RE: Response to City Review Comments
Level I Site Plan Development Review Application

Motley Street Extension, Portland, Maine

DRAINAGE PLAN

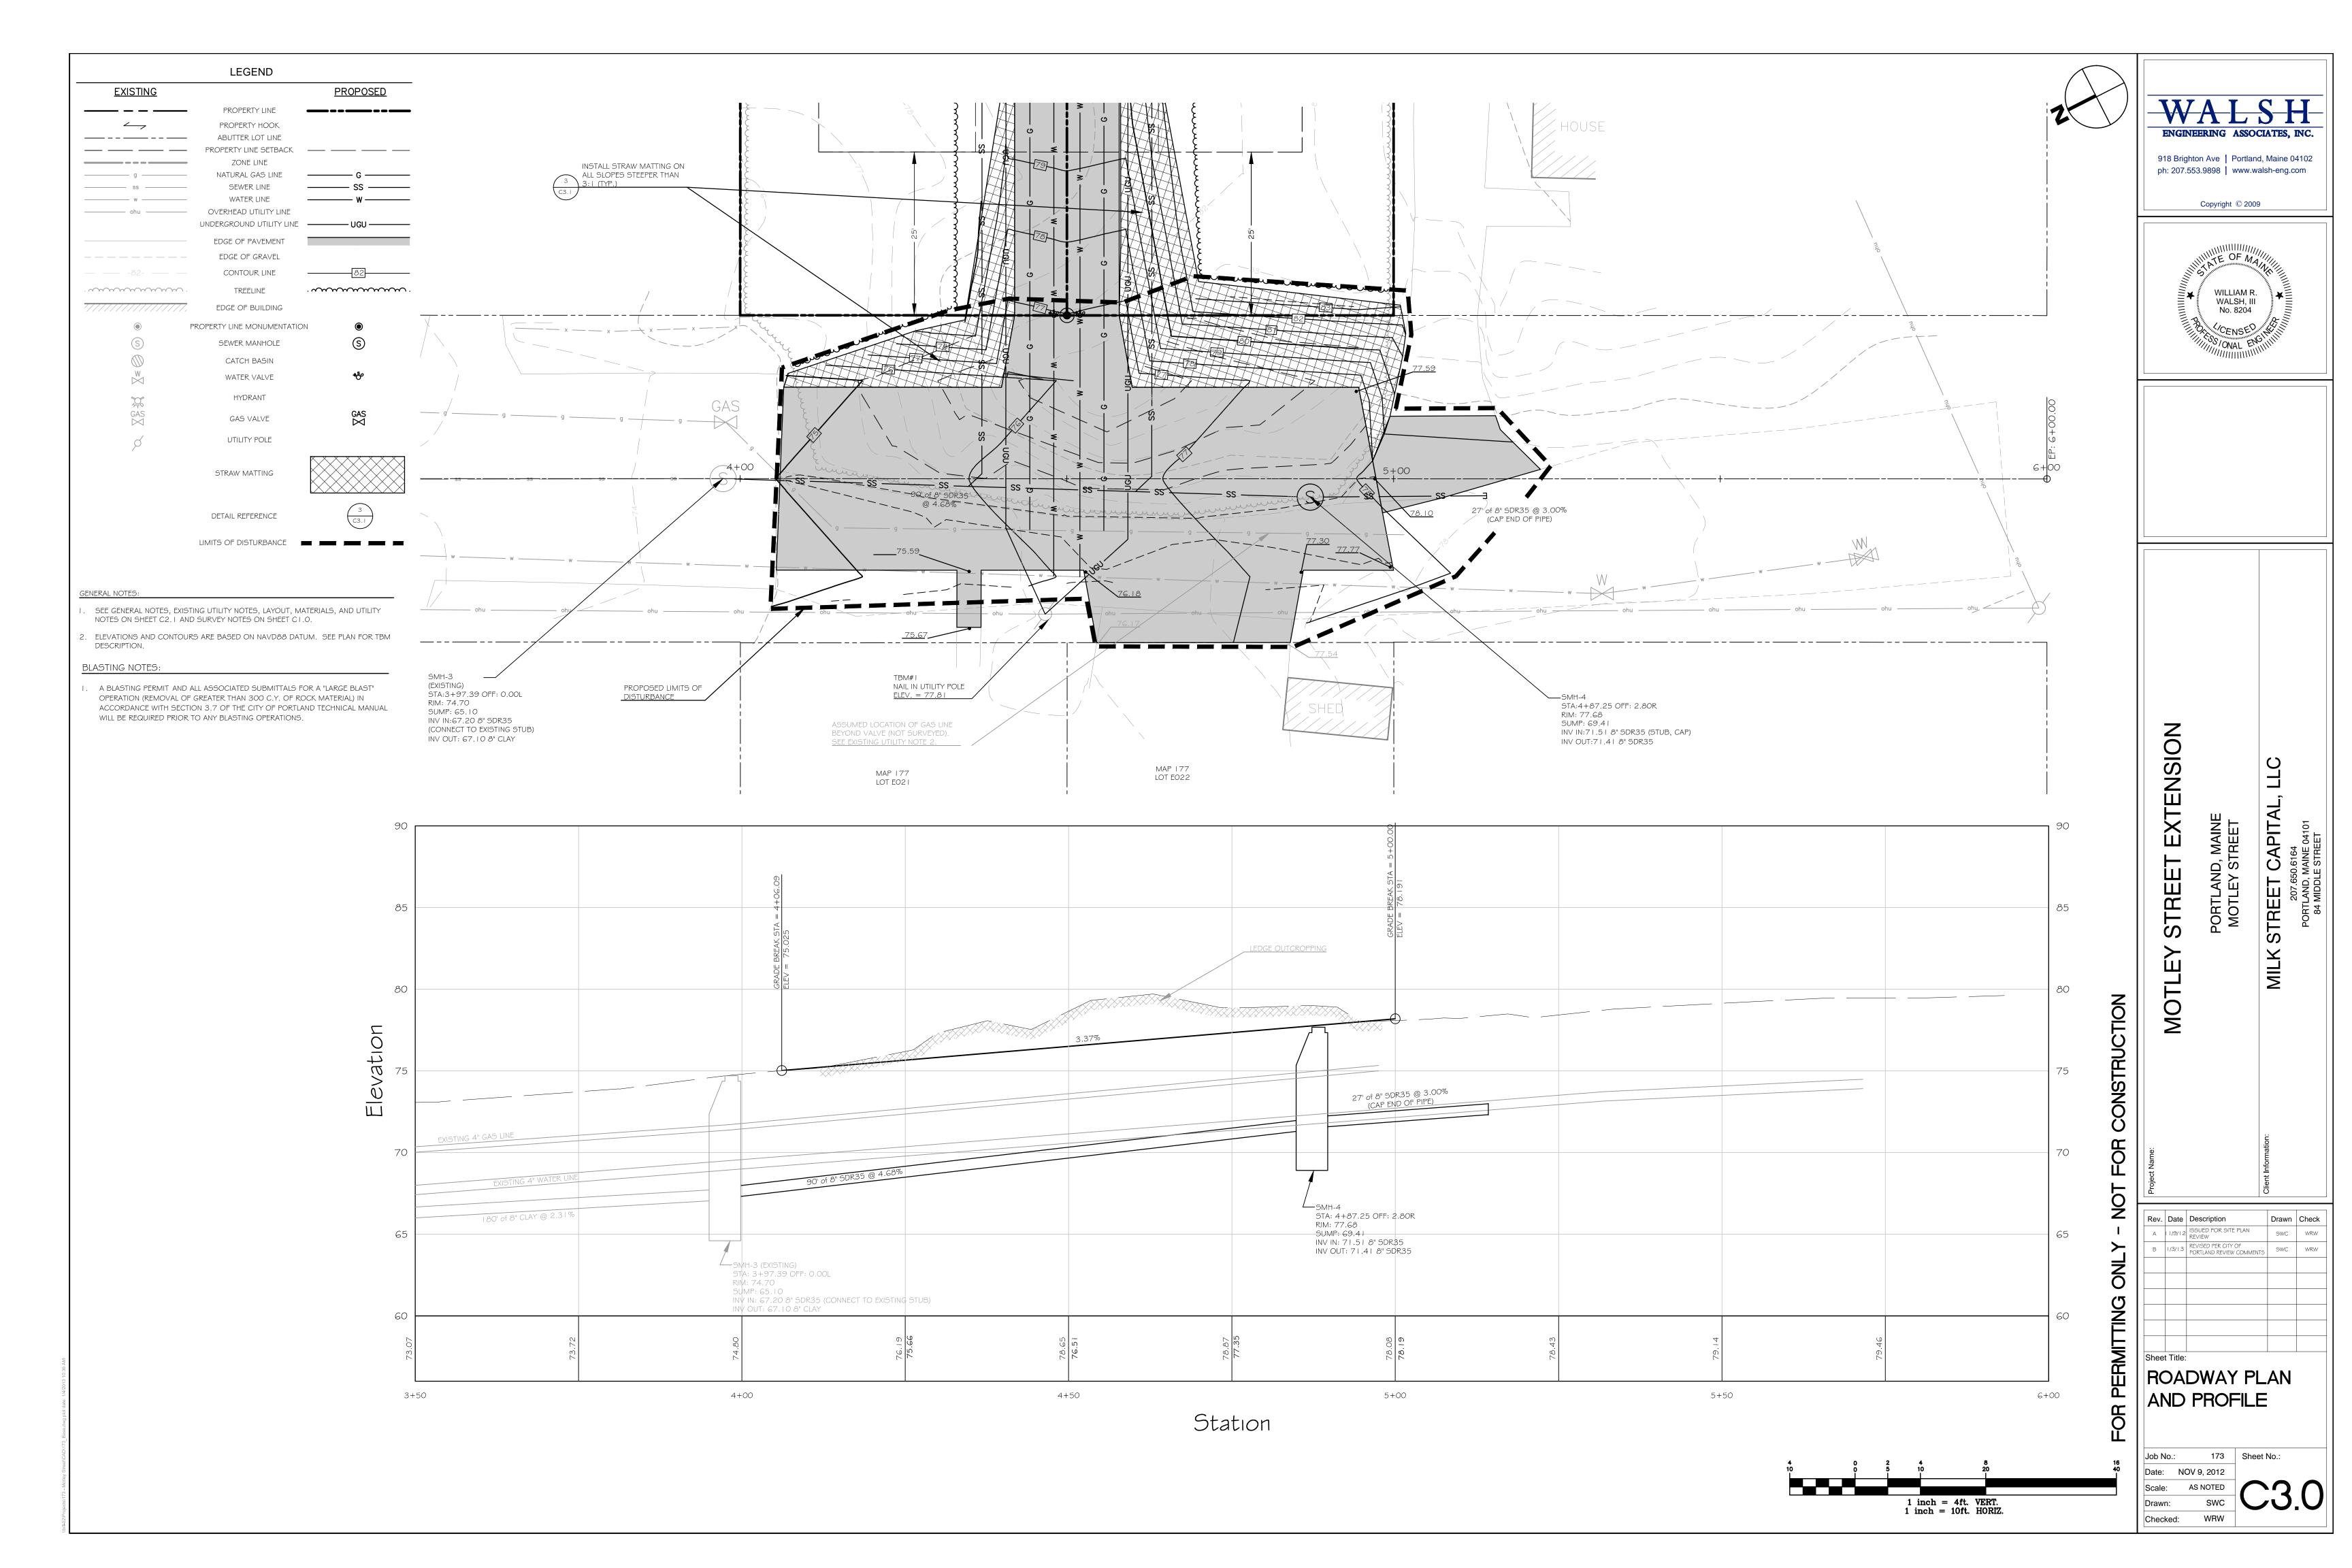
Catch basin inlet protection provisions have been added to the site plans. A symbol and leader note have been added to sheet C2.1 and the appropriate detail has been added to sheet C3.2 (detail #7).
